21 January 2010

**Re: SSROC Submission on EnergyAustralia's Submission for the AER's  
Redetermination of Public Lighting Prices 2010 to 2014**

**Street Lighting Labour Productivity Assumptions:**  
*Lighting Repairs / Day by a 2-person crew in urban areas*

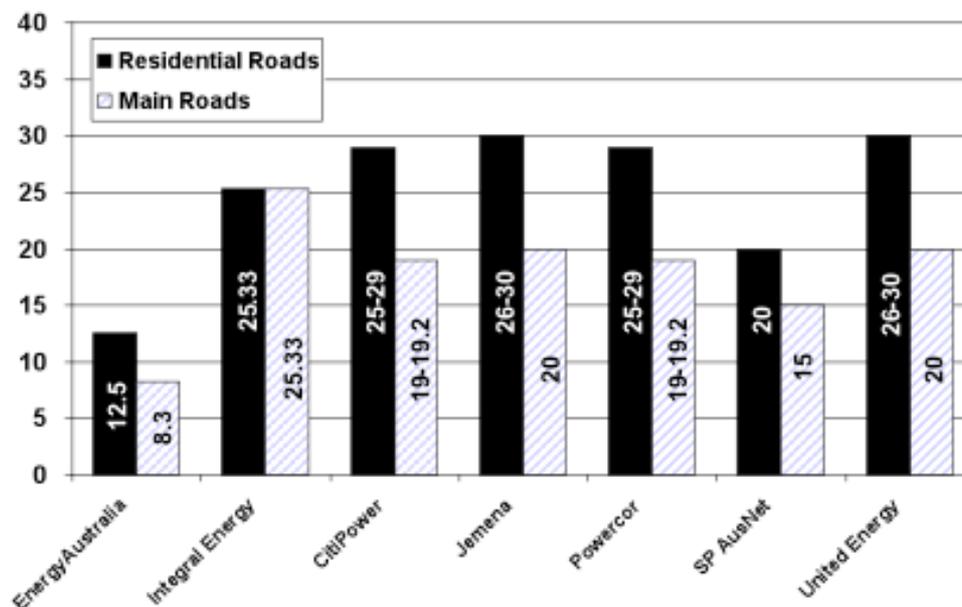
Labour assumptions are at the core of O&M costs. In its redetermination submission to the AER, EnergyAustralia cites a variety of interim submissions to the ESCV’s 2003-04 review of public lighting service charges as proported evidence that the ESCV labour assumptions were not credible. Notably, EnergyAustralia does not cite the ESCV’s final decision which took into account the DNSP submissions nor does it consider the 30 November 2009 submissions by the five Victorian DNSPs to the current 2011-2015 AER pricing review.

The figure below compares spot maintenance assumptions as submitted by Victorian DNSPs in November 2009<sup>22</sup>, Integral Energy’s labour assumptions as approved by the AER in April 2009<sup>23</sup> and EnergyAustralia’s spot maintenance assumptions<sup>24</sup> as per its redetermination proposal. **Overall it can be seen that, on average, other utilities are assuming labour productivity in completing repairs at approximately twice that of EnergyAustralia.**

## Street Lighting O&M Prices / Year for Key Lights: EnergyAustralia 2010 Proposal vs VIC DNSPs 2011 Proposals

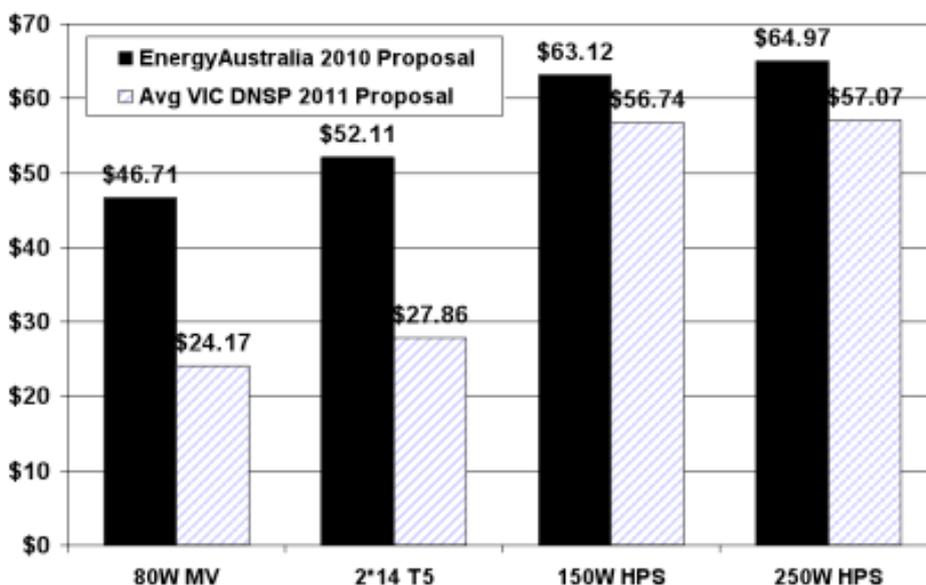
EnergyAustralia's overall O&M charges for FY2010 appear high compared to FY2011 price proposals made by Victorian DNSPs in the current AER review<sup>29</sup>. The figure below illustrates O&M pricing proposals by EnergyAustralia in its redetermination submission for four key lighting types as compared to the average price proposed by Victorian DNSPs. Notably, the greatest differences are in minor road lighting which accounts for approximately 70% of all lights in EnergyAustralia's lighting portfolio. The differences would be even greater if the figures were adjusted for inflation.
